Report to the Plan Commission

Legistar ID: # 29226 and 29227
1902 Tennyson Lane and 3802 Packers Avenue
Demolition Permit and Certified Survey Map (CSM)

Report Prepared By:
Kevin Firchow, AICP
Planning Division

Requested Action: The applicant requests approval of a demolition permit and a three-lot land division by certified survey map (CSM) for future development.

Figure 1: Raemisch Property Development Concepts - Northport-Warner Park-Sherman Neighborhood Plan

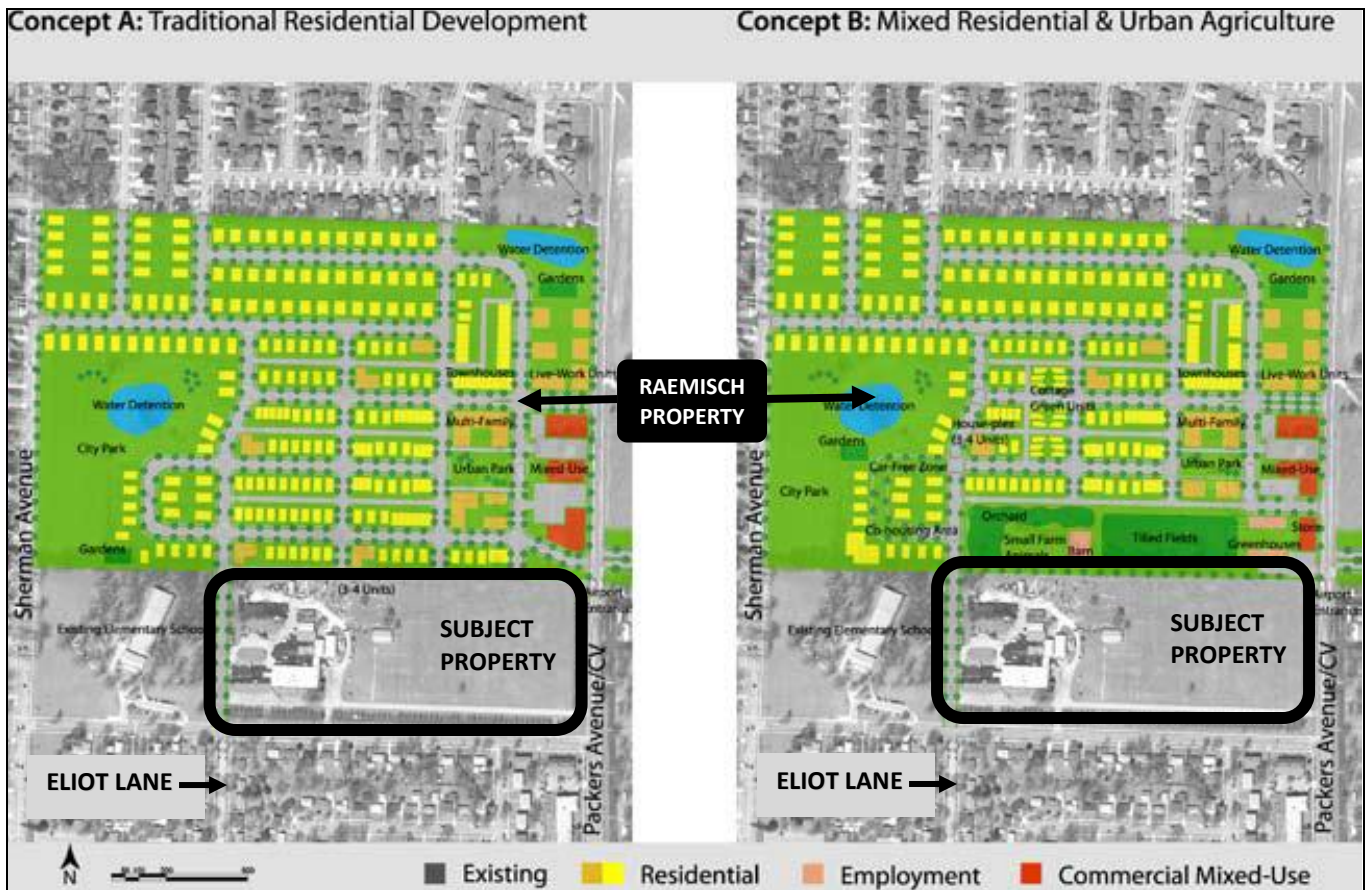
The Northport-Warner Park-Sherman Neighborhood Plan recommends that the future use of this site “could focus on residential uses with an opportunity for a limited neighborhood mixed-use node at the intersection of Packers Avenue and Tennyson Lane.” This plan does not include detailed site-specific planning and street-layout recommendations for the subject site. However, the plan includes several conceptual designs shown for the Raemisch property to the north. Those concepts, included below, show the extension of Eliot Lane extended north through this site to connect to the Raemisch property, which now terminates at Tennyson Lane near the southwest corner of the subject site. Further, the plan’s Transportation Improvements map also recommends the extension of Eliot Lane to the north. One of the conceptual designs for the Raemisch property indicates three additional streets extending south to the subject site.

The demolition of the existing structures would remove a use that is inconsistent with adopted plans, and the CSM to convert the existing two lot configuration to three lots isn't in itself inconsistent with these plans. That leaves the public street location as the key question related to plan consistency. As shown above, these general concept plans included in the Northport Warner Park-Sherman Neighborhood Plans, suggest between one and four future connections extending into the subject site depending on how future development on the property to the north occurs.

Figure 2: Conceptual Street Layout Study - Sketch #1 (Prepared by the Planning Division)

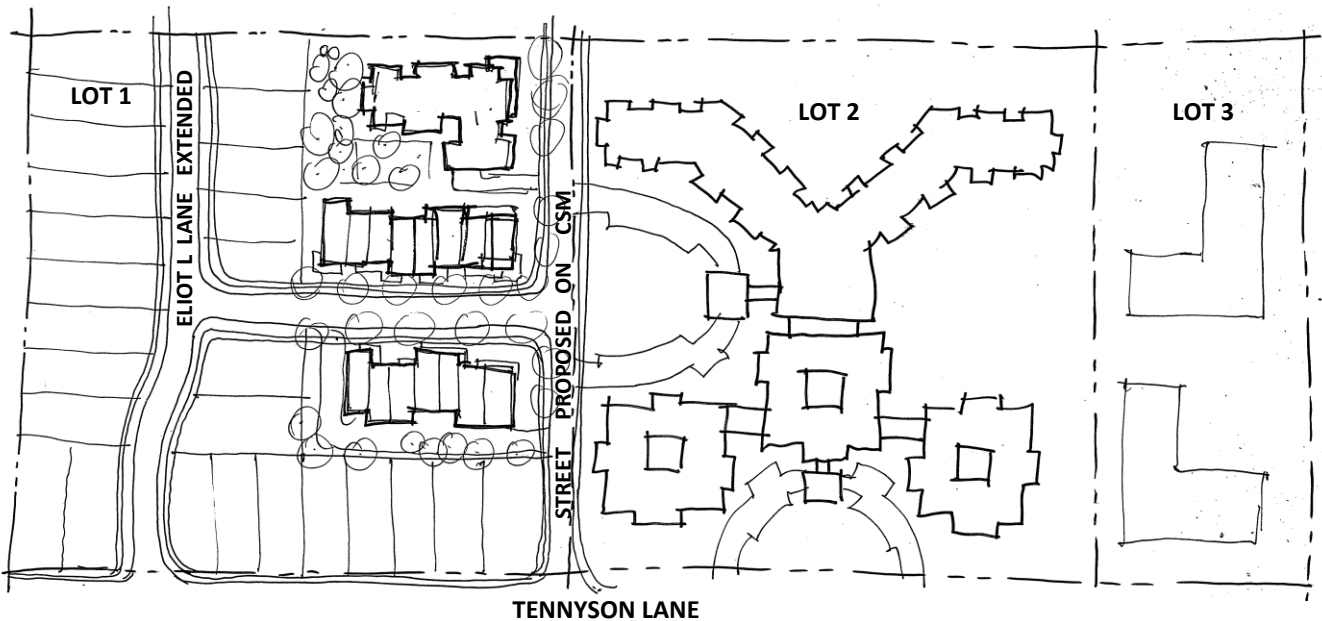
The first concept study (Figure 2) shows a future development pattern based on the midblock street proposed by the applicant. This sketch also shows the plan-recommended extension of Eliot Lane. With the spacing between the Eliot Lane extension and the proposed street, there would be enough room for a future east-west street that would allow development to front onto Tennyson Lane. Single-family homes currently front the opposite side of Tennyson Lane.

- The applicant's proposed midblock connection would allow for the option of an additional east-west street parallel to Tennyson Lane, perpendicular to an Eliot Lane extension. This likely couldn't be achieved if the midblock street was shifted much to the west.

- The site layout should allow for uses to front Tennyson Lane. The preferred way to achieve this would be through additional east-west streets (Conceptual Sketch #1) or turning the lots between Eliot Lane and a midblock street (Conceptual Sketch #2). In the latter case, the midblock connection could be shifted to the west from the proposed location in order to avoid unusually deep lots, as shown.
- While not specifically identified on the adopted plans, a Kipling Drive extension to the north may be a beneficial and necessary street connection depending on what is ultimately developed on Lots 2 and 3 and final street pattern. Staff understands that Independent Living is currently looking for an 8 acre site should they move forward with their plans. Staff notes that an extension of Kipling Drive extension would result in a smaller Lot 2.

Figure 3: Conceptual Street Layout Study - Sketch #2 (Prepared by the Planning Division)

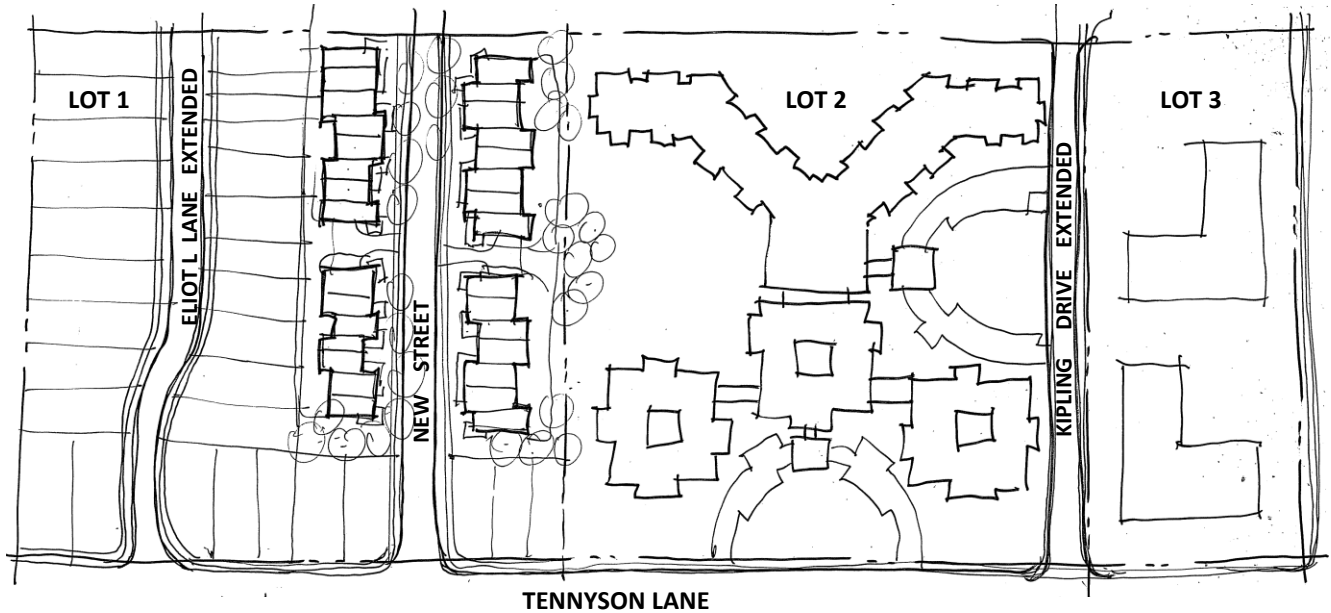
The second concept study (Figure 3) shows a future development pattern with three north-south streets, though not the north-south street proposed on this CSM. The midblock street is shifted to the west. As shown, development could still front onto Tennyson Lane. As on Figure 2, the plan-recommended extension of Eliot Lane is shown. Also shown in this concept is a potential extension of Kipling Drive. Though not specifically recommended in the adopted neighborhood plan, this street connection is implied in one of the Raemisch property development concepts in Figure 1 of this report.
